Response to reviews for GMD manuscript gmd-2021-193 Maher and Earnshaw 2021

Response to Reviewer 1

Response to Reviewer 2

Figure 1. v component of the wind (left) and omega (right) for the fixed SST Flex-UM experiment.

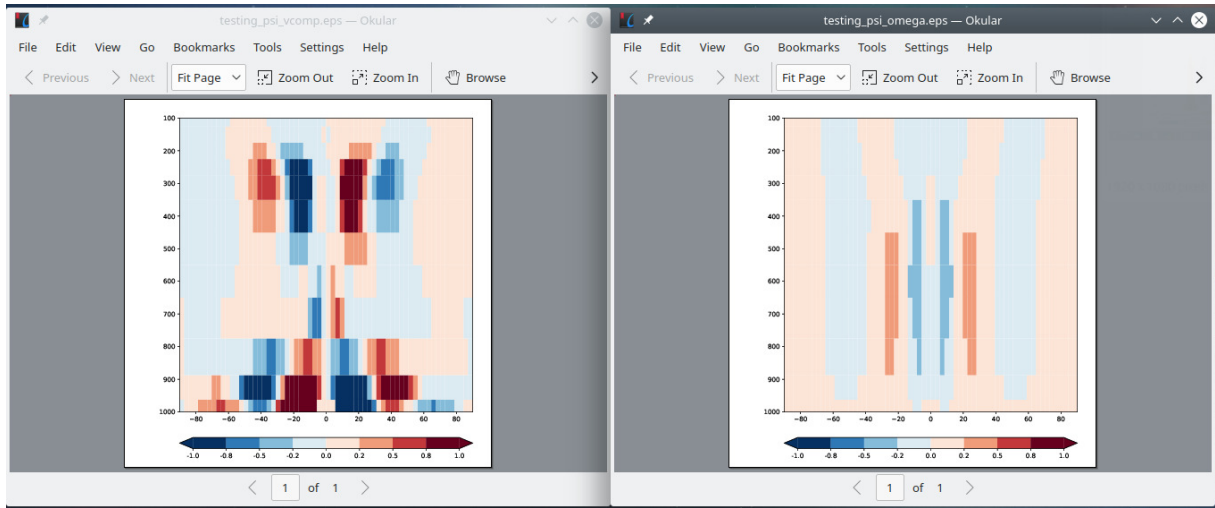
What is the artifact in ψ referred to in the manuscript?

ψ is computed by integrating omega and the v component of wind. The climatologies of these fields are shown in Fig.1.

Figure 2. Riemann sums for the v wind integrated wrt pressure. Top panel (L and R): left Riemann sum and right Riemann sum. Bottom pane; (L and R) integration using the cumtrap python method and the average of the left and right Riemann sums.

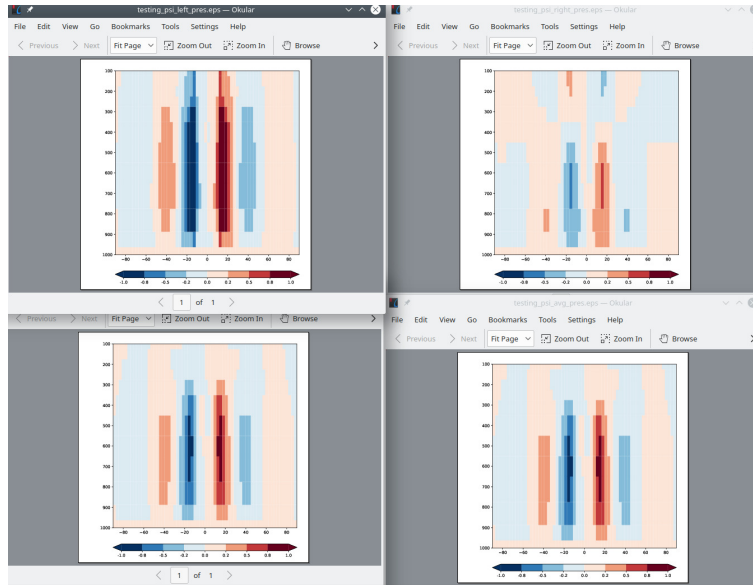
5. *P10, L15 onwards: I find this explanation too simplified and sketchy. How does the limited resolution impact the distribution of v and ω , and what integration artefacts are meant?*

The integration was computed using left and right Riemann sums. Python can compute these using the cumtrap function (part of the scipy library `scipy.integrate.cumtrapz`), however, this method does not handle masked data and so it was not used (it was used to check the Riemann sums only). The left and right Riemann sum for the v wind integrated with respect to pressure are shown in Fig. 2. The average of the two Riemann sums (bottom right of Fig. 2) does not have an integration artifact over the NH polar region. The left and right Riemann sum for omega integrated with respect to latitude are shown in Fig. 3. In the left, right, and average Riemann sum plots for omega the NH polar region has an unrealistic circulation (what we
